GL1500 CB RADIO SUB-HARNESS

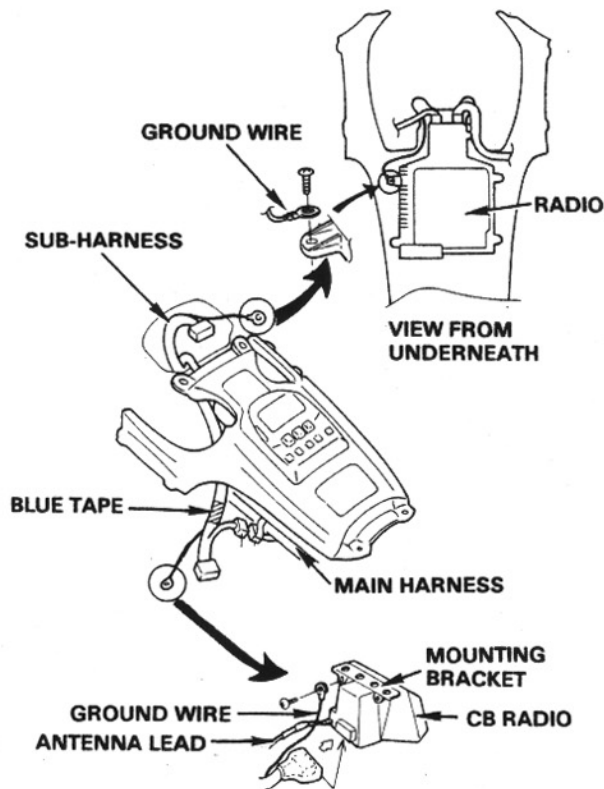
For future identification, remove the left fairing side pocket. A ground wire attached to the CB mounting bracket indicates the new sub-harness (or a CB with serial number 6656 or above) has already been installed. The sub-harness for this repair is also wrapped with blue tape in the area shown above.
